# PACKARD MOTOR CAR COMPANY

February 14, 1929

Subject: OIL PUMP RELIEF VALVE

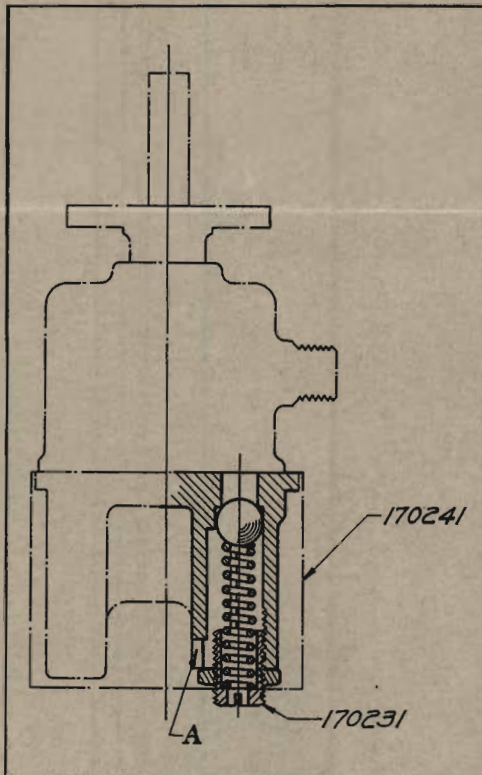
A change has been made in the oil pump relief valve starting with motor #258010 in the 626-33 and motor #174625 in the 640-45.

In the new design the valve must leave its seat a considerable distance in order to permit the oil to by-pass through the pump and return to the crankcase through the outlet passage. In the old construction only a slight movement of the valve was necessary in order to relieve the excess pressure.

The purpose of the change is to overcome the oil pump chatter which sometimes developed when the motor was started, or when the oil level in the crankcase was low. This chatter was due to the fact that air as well as oil was passing through the relief valve, and since the air was unable to hold the valve away from its seat, a noise was set up by the rapid movement of the ball. In the new construction the ball is forced so far from its seat by the oil that it does not return even when the mixture of air and oil is passing it.

In those cases where the customer complains of the oil pump noise a correction can be made by ordering:

- 1—170241 Motor Oil Pump Body Cover Assembly
- 1—170231 Motor Oil Pump Relief Valve Adjusting Screw

The two new parts should be assembled with the remainder of the old pump as shown in the illustration.
